## THE NETWORK RAIL (OLD OAK COMMON GREAT WESTERN MAINLINE TRACK ACCESS) ORDER

## REBUTTAL EVIDENCE OF ANDREW FLEMING

1 NOVEMBER 2023

1 JEWSONS YARD RRP GENERAL ARRANGEMENT  
100001 SCALE 1:100

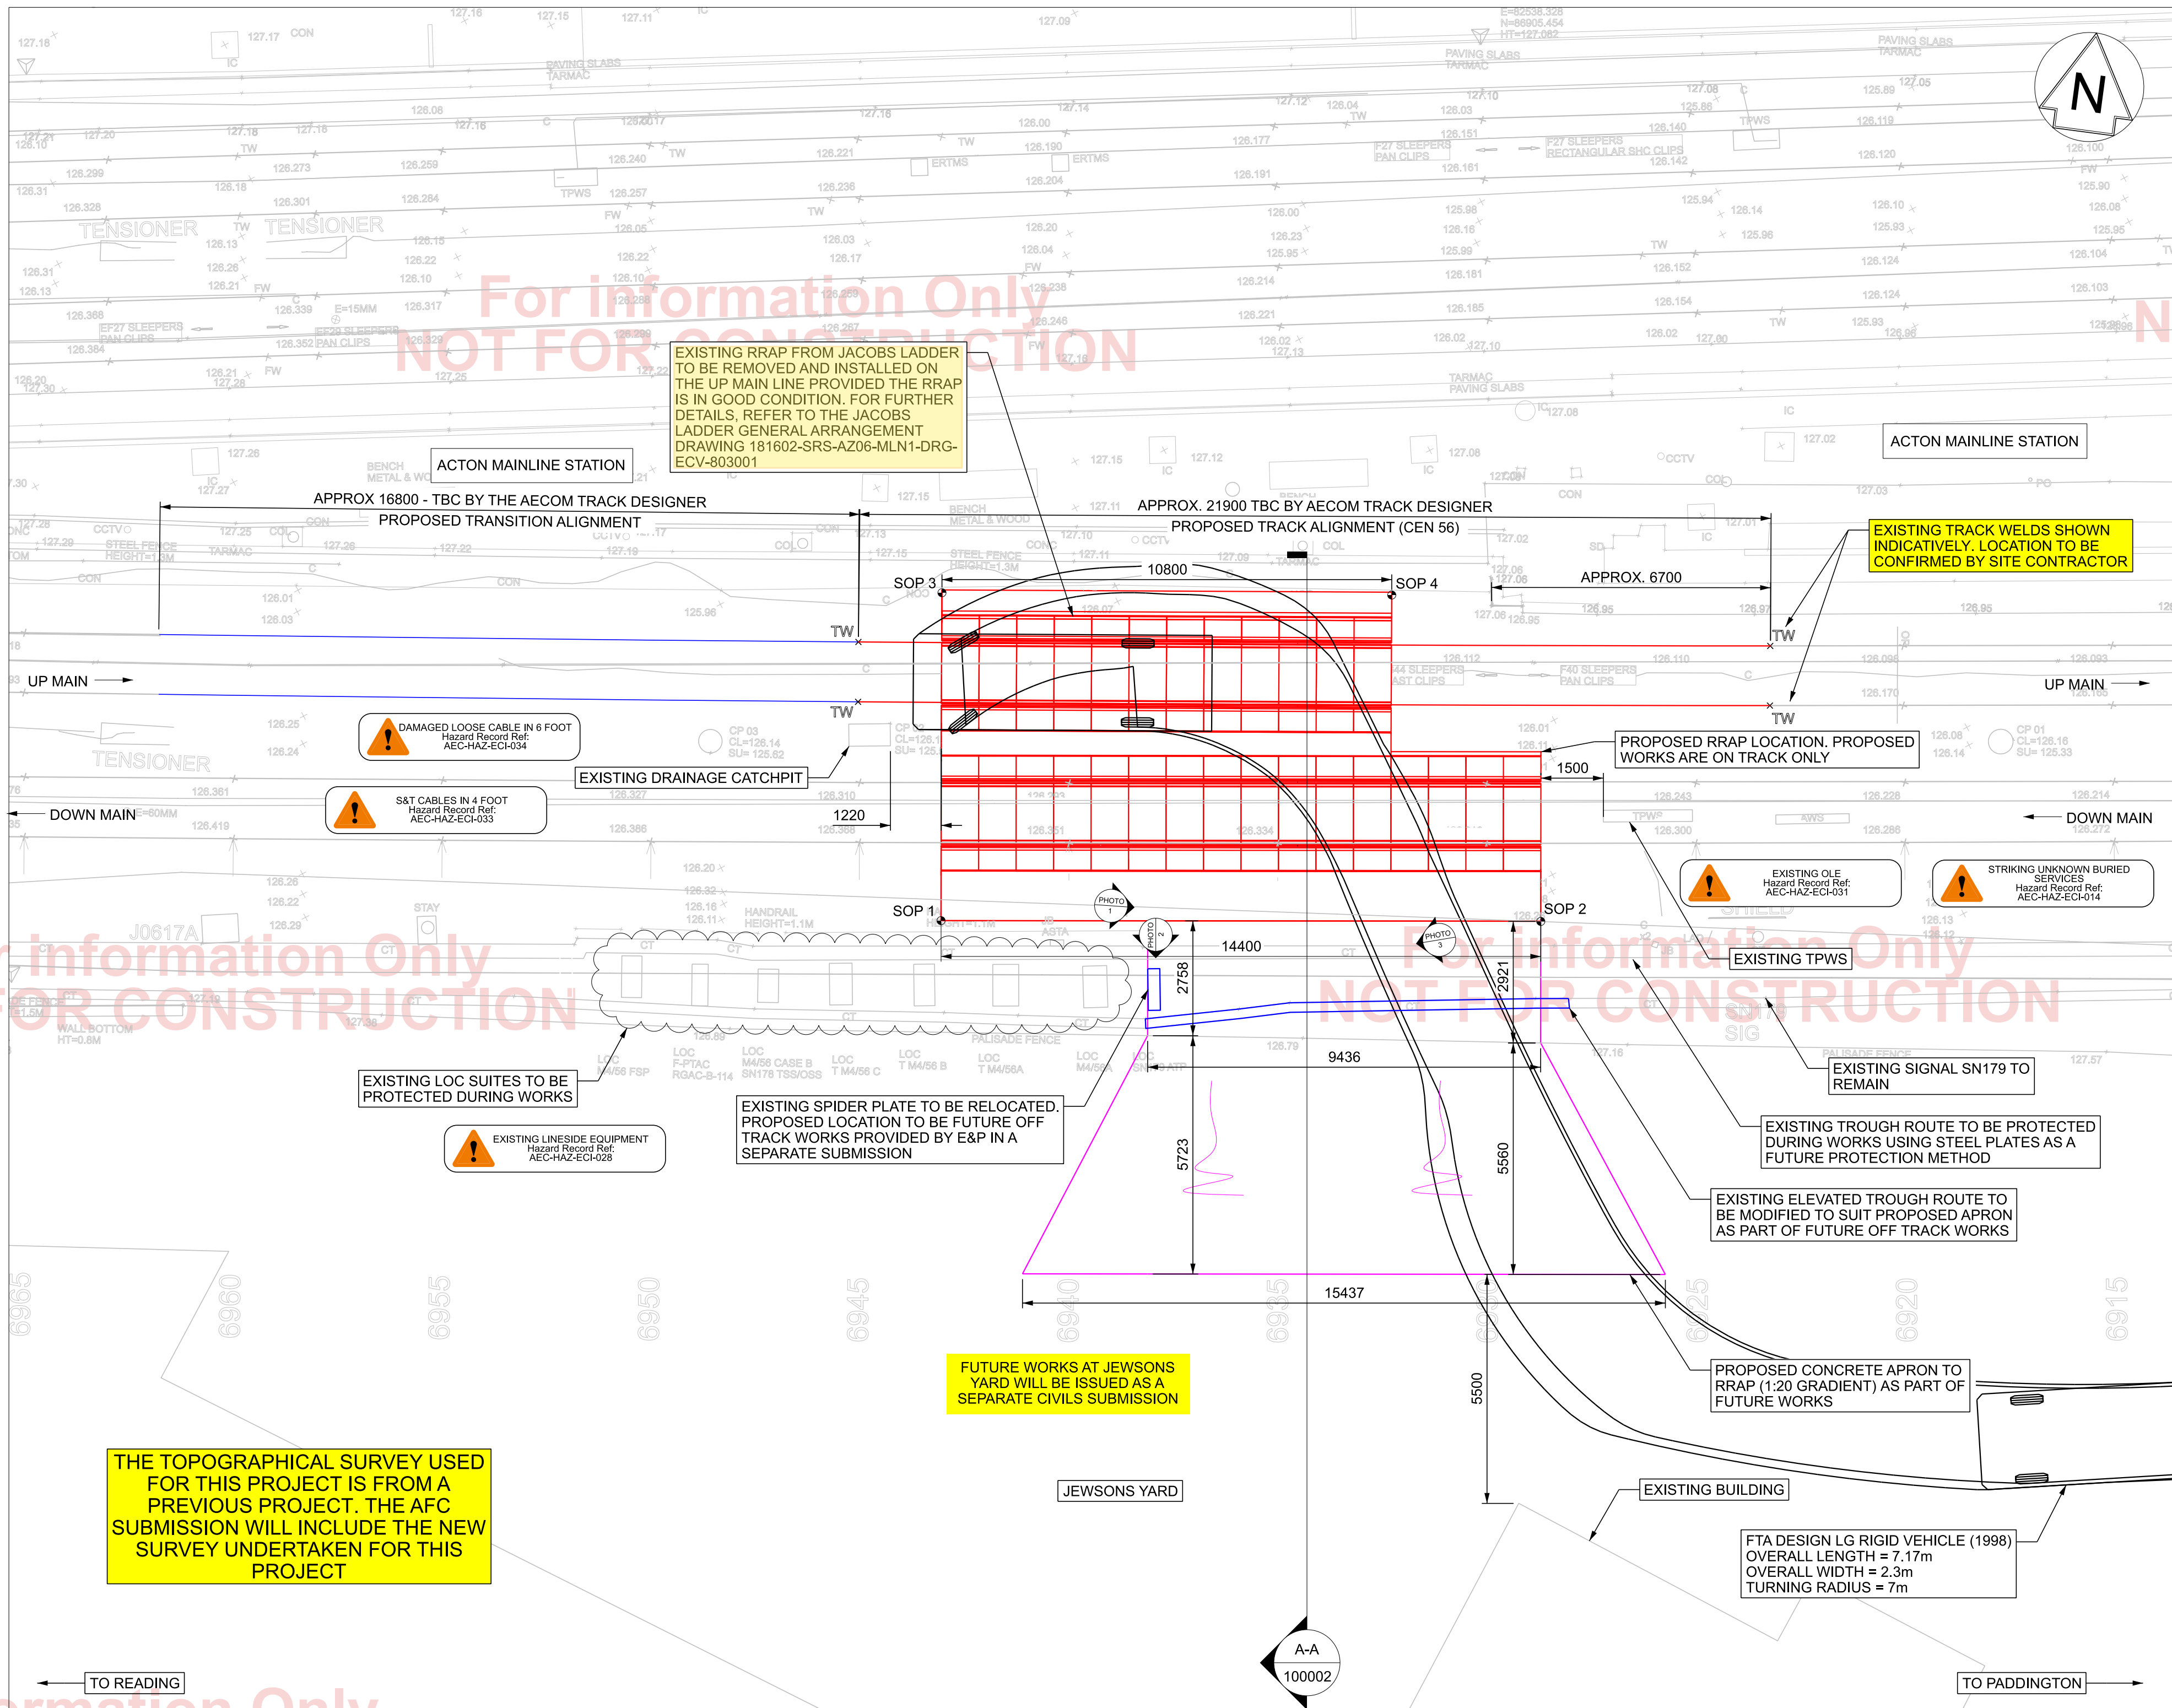
Section 4.12i)	Drawing NR09 produced by Network Rail for the proposed temporary RRAP shows the eastern edge of the hardstanding across the rails fouling a critical part of the main line signalling system known as the Train Protection Warning System (TPWS)	<p>The design of the RRAP to detailed design is still on-going, I can confirm that the latest designs do not foul the TPWS.</p> <p>This is evidenced in the attached drawing 181602-SRS-AZ03-MLN1-DRG-ECV-100001 P02.</p>
Section 4.12ii)	Drawing NR09 also shows the northern edge of the RRAP in close proximity to Acton Main Line station platform. The RRVs will have to come onto the RRAP with the rail undercarriage retracted before turning 90° to face the direction of travel on either of the Main Lines before deploying the rail wheels. A general arrangement drawing showing a section through the temporary RRAP has been produced and is attached at Appendix R, for a typical RRV which might be expected to use the facility (other RRV designs may be longer or shorter than this). If the RRV as shown attempted to centre itself on the GWML Up Main Line nearest the island platform at Acton Main Line station in order to perform the 90°manoeuvre, the RRV would collide with the edge of the platform. Contrary to the guidance in CD34, it is therefore a concern that the drawing presented could result in RRV fouling a lineside structure ;	<p>The design of the RRAP has been progressed with the platform at Acton Main Line Station in mind. The RRAP on the Up Main is staggered from that of the RRAP on the Down Main to be aligned with a narrower section of the platform to minimise the interface between them. This also allows RRVs to approach the RRAP on the Up Main from a lesser angle than the 90° suggested in the PoE of Mr. Gallop. This has been confirmed by vehicle tracking.</p> <p>This is evidenced in the attached drawing 181602-SRS-AZ03-MLN1-DRG-ECV-100001 P02.</p>
